LICENSEE EVENT REPORT

PLANT E. I. HATCH UNIT II
PRIMARY CONTAINMENT COOLING MODIFICATION

E. I. Hatch Nuclear Plant Unit 2
Bechtel Job 6511-020
Drywell Cooling System Modifications
and Post-Modification Testing
File: A-29.3/SS-2102-160/SS-2115-2/B-GP-5899

DRYWELL COOLING SYSTEM PROBLEMS

FIGURE 1

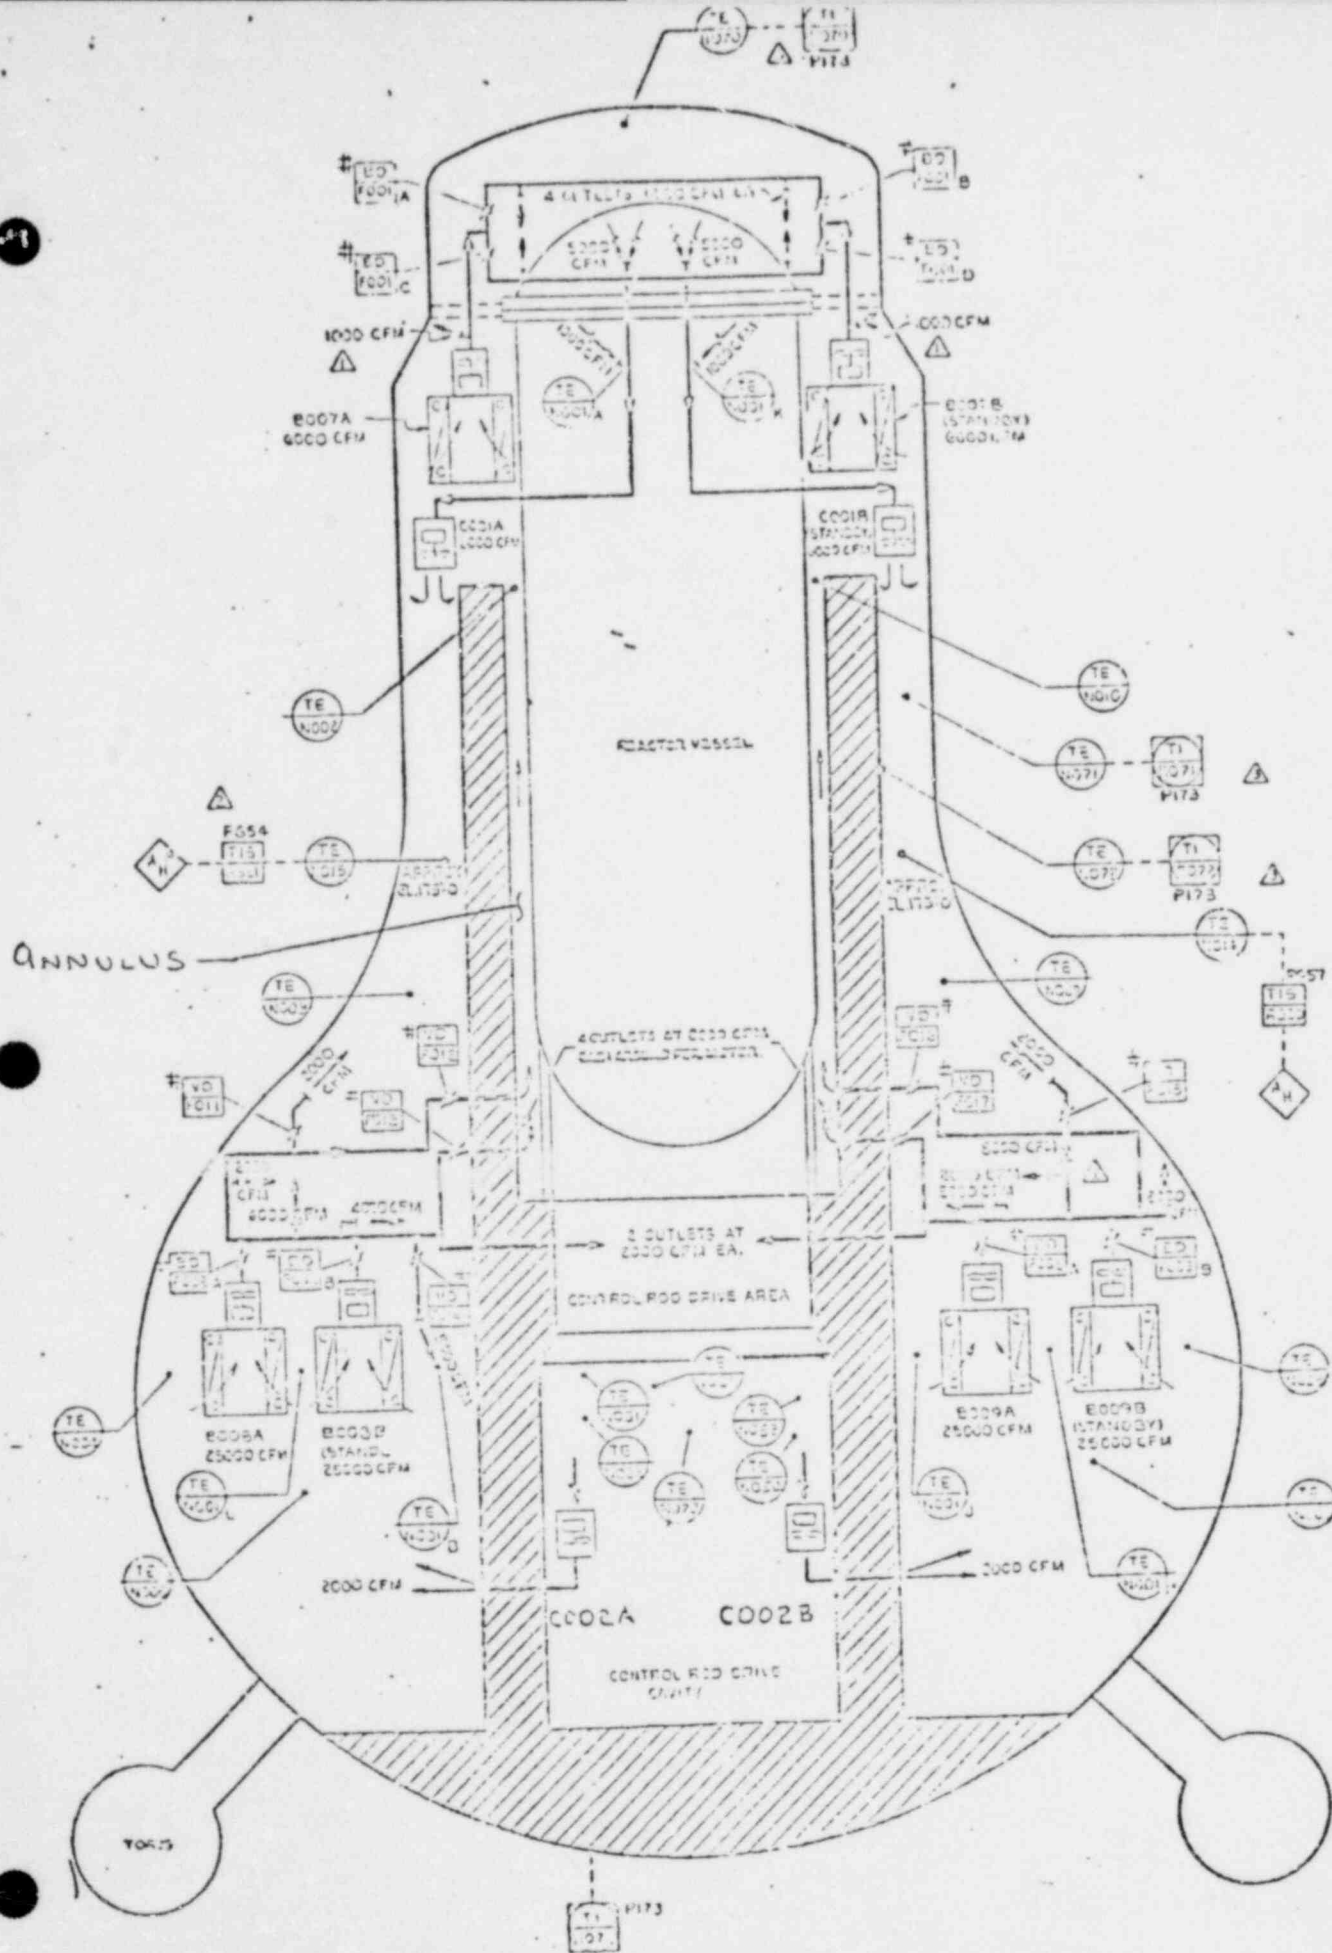
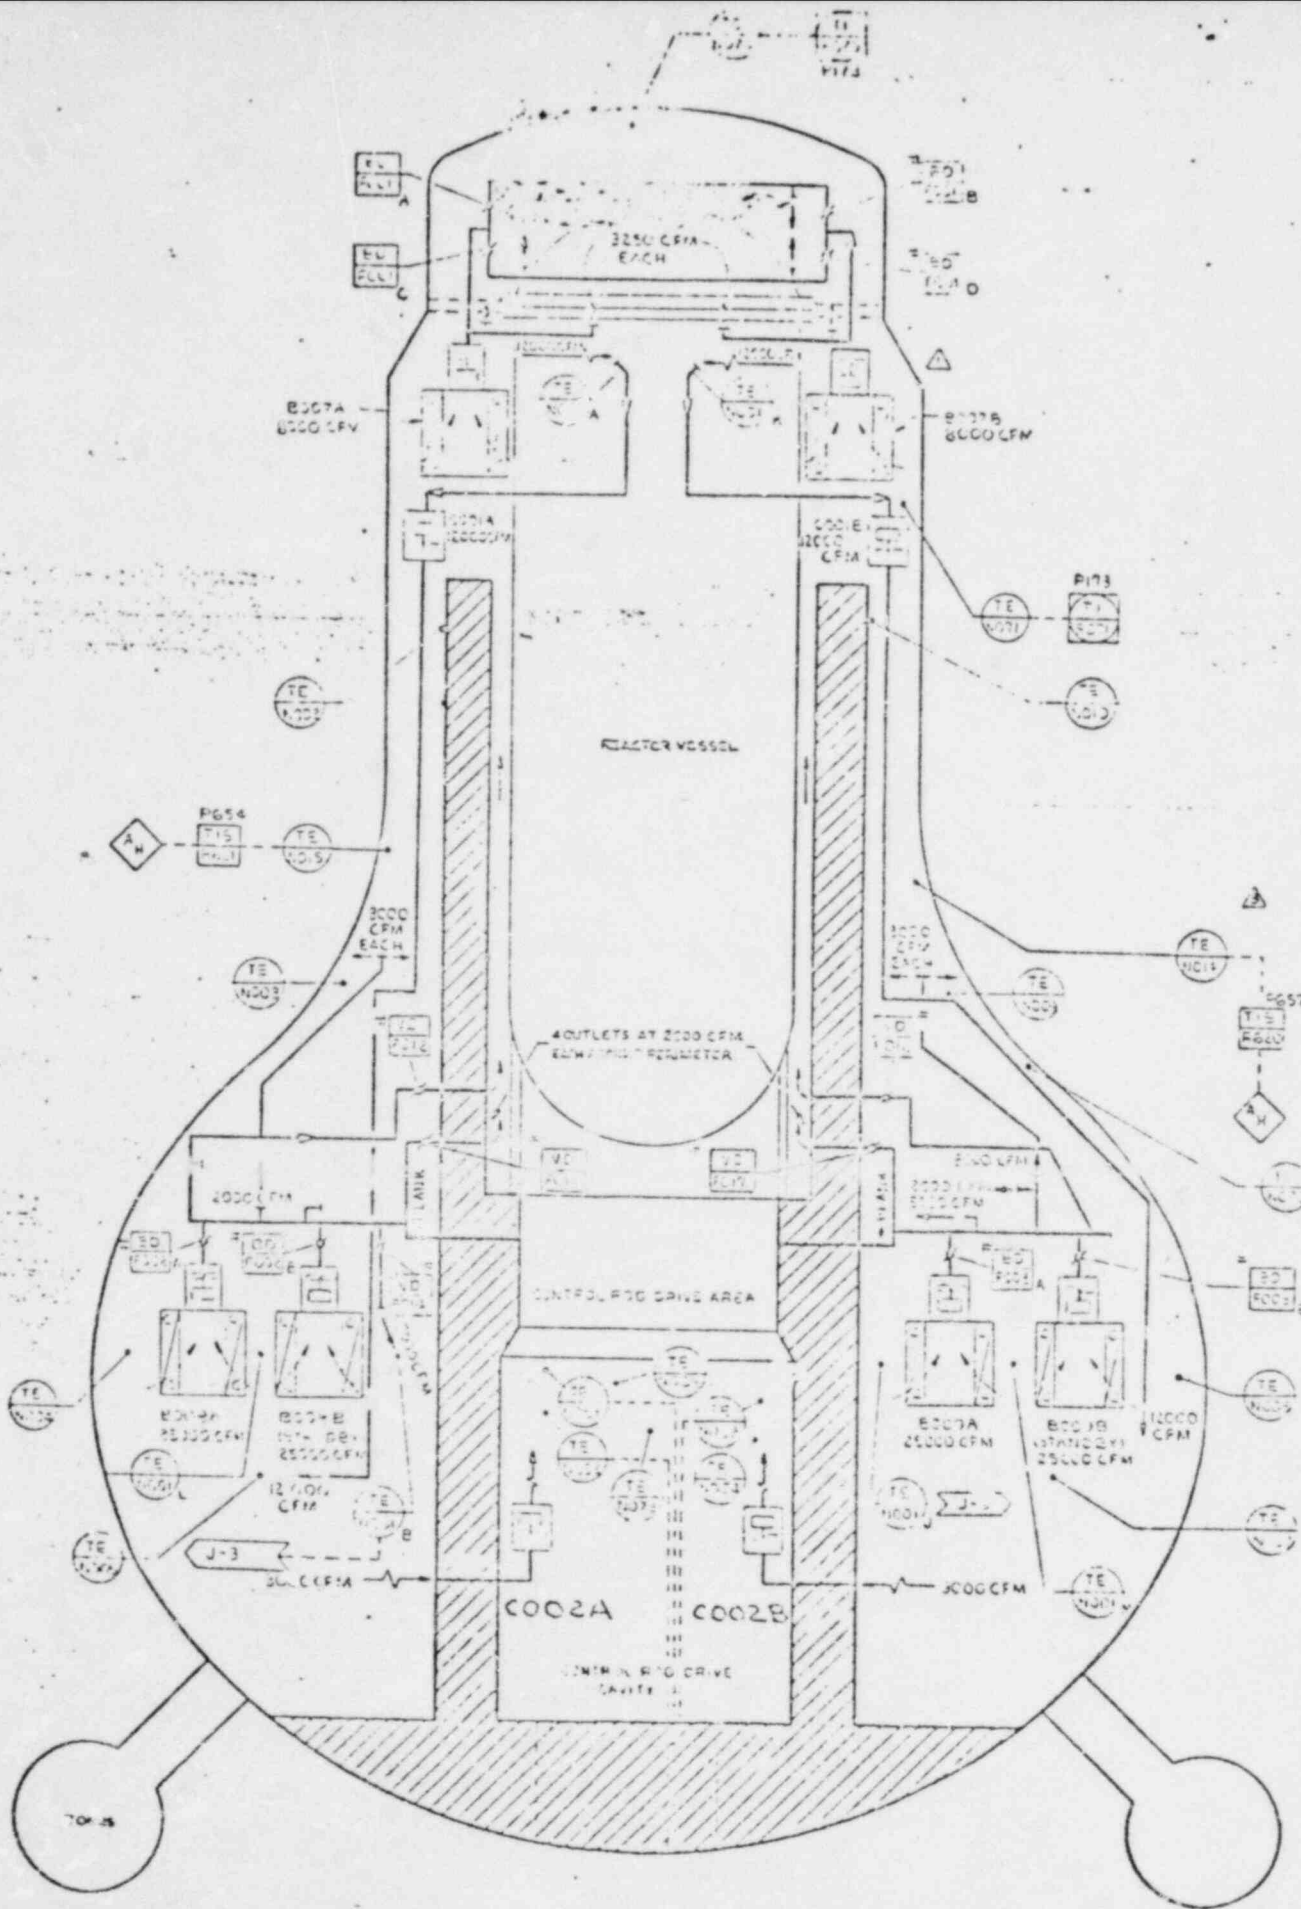
Figure 1 shows the original Drywell Cooling System design schematically. The original fan line up was to have the following fans running: 2T47-B007A, 2T47-B008A, 2T47-B009A, 2T47-C001A, 2T47-C002A and 2T47-C002B with the other four fans in standby. With this line up, 4000 cfm was being supplied to the CRD cavity area by 2T47-B008A and 2T47-B009A, 4000 cfm was being exhaust the CRD cavity area by recirculation fans 2T47-C002A and 2T47-C002B. Fans 2T47-B008A and 2T47-B009A were also to supply a total of 8000 cfm to the annular space between the sacrificial shield and the reactor vessel insulation. This 8000 cfm was to travel up the annulus picking up

Figure 2 shows the resulting Drywell Cooling System design. The present fan line up is: 2T47-B007A, 2T47-B007B, 2T47-B008A, 2T47-B009A, 2T47-C001A, 2T47-C001B, 2T47-C002A, and 2T47-C002B running with 2T47-B008B and 2T47-B009B in standby. The only logic change needed to accomplish this was to remove the interlock between 2T47-B007A and 2T47-B007B which prevented both fans from running simultaneously.

A ring header extending 90 degrees around the drywell from east to south was tied into the existing discharge duct of B007A as seen in Figure 3. This ring header delivers 6500 cfm to the upper drywell through two outlets as seen in Figure 4.

AS SHOWN ABOVE, MODIFIED TO ADD FOUR VENT
DUCT RISERS AND 180° ROLLED DUCT AT VIEW

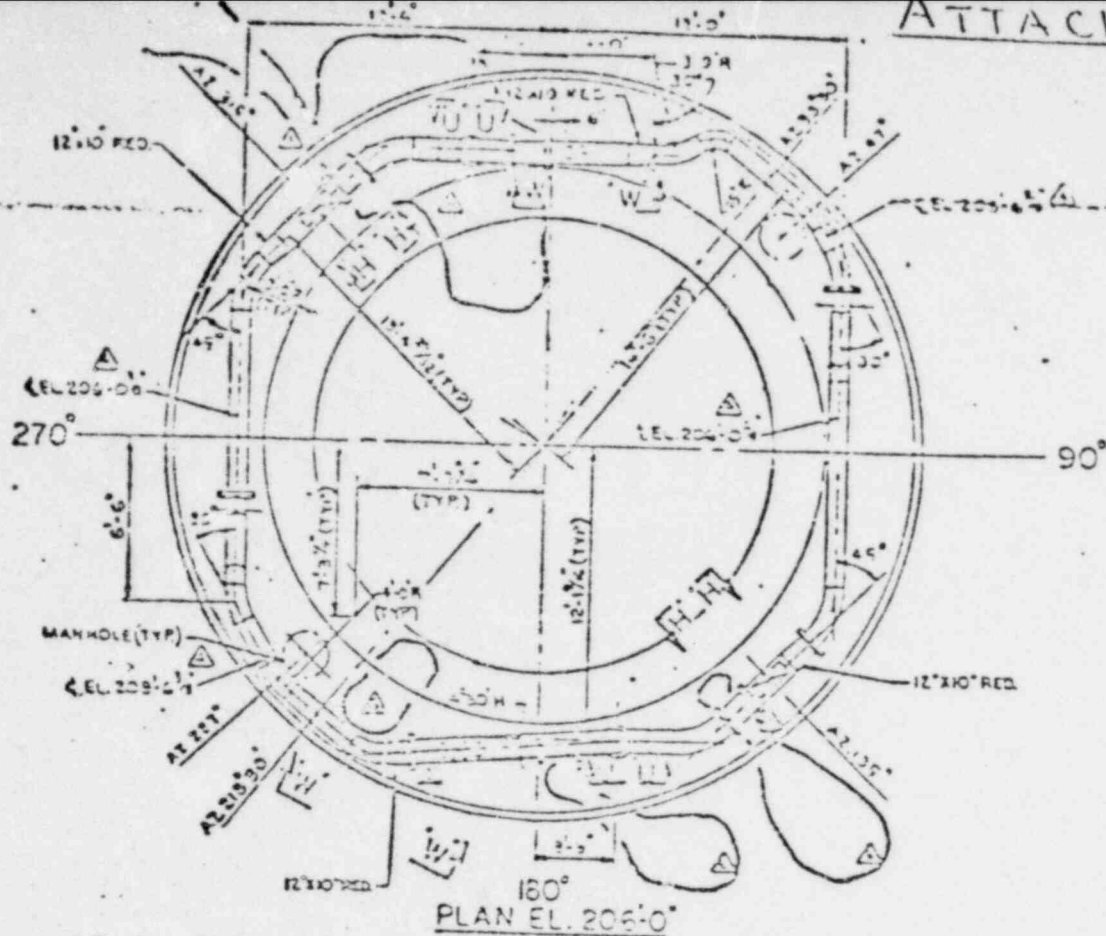
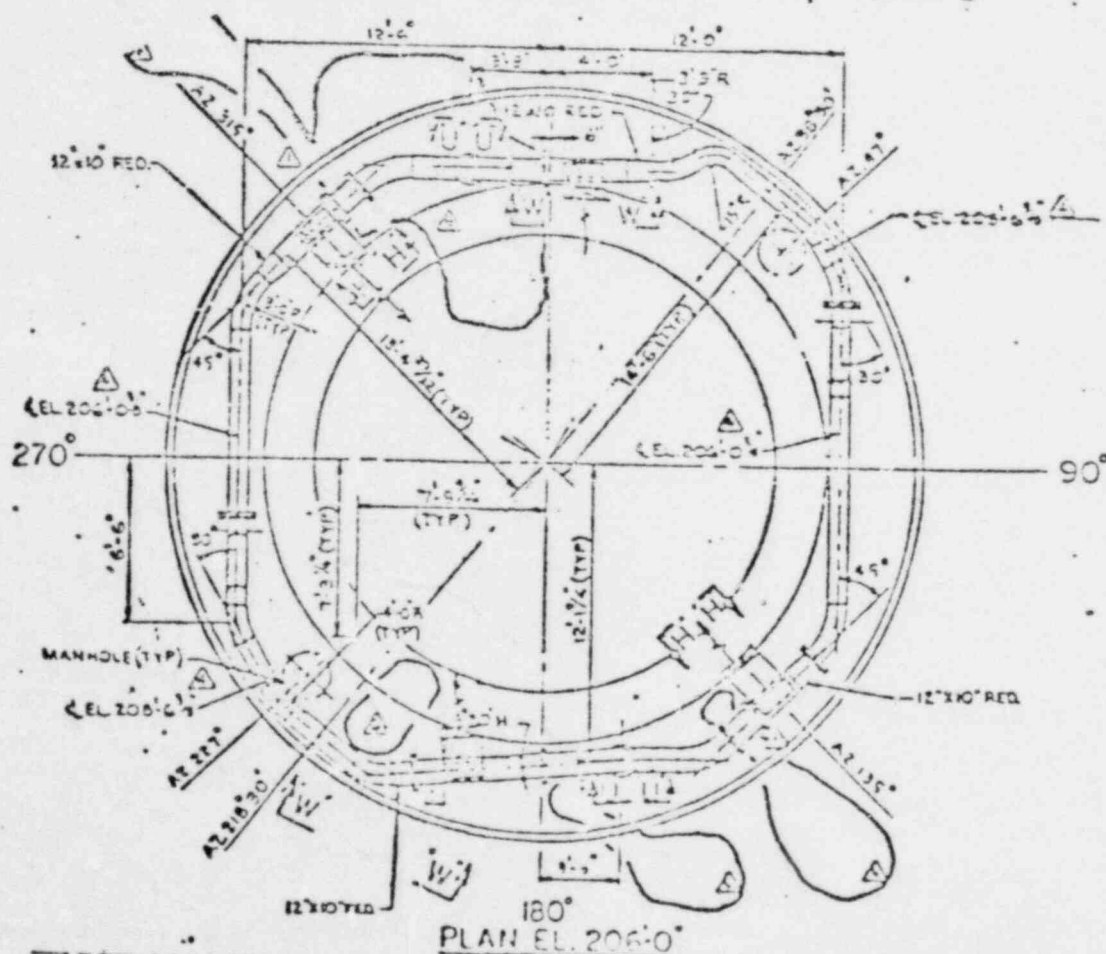
- A. Additional modification will be required, during the first refueling outage, for the ductwork above the reactor well bulkhead, to enhance air distribution in the volume over the RPV head (see attached sketch) and,
- B. In order to regain cooler redundancy, the RPV insulation system problems must be corrected, at least for the insulation above the top of the sacrificial shield wall. (i.e. - above el. 188'0") Refer to problems report attached, for more information.
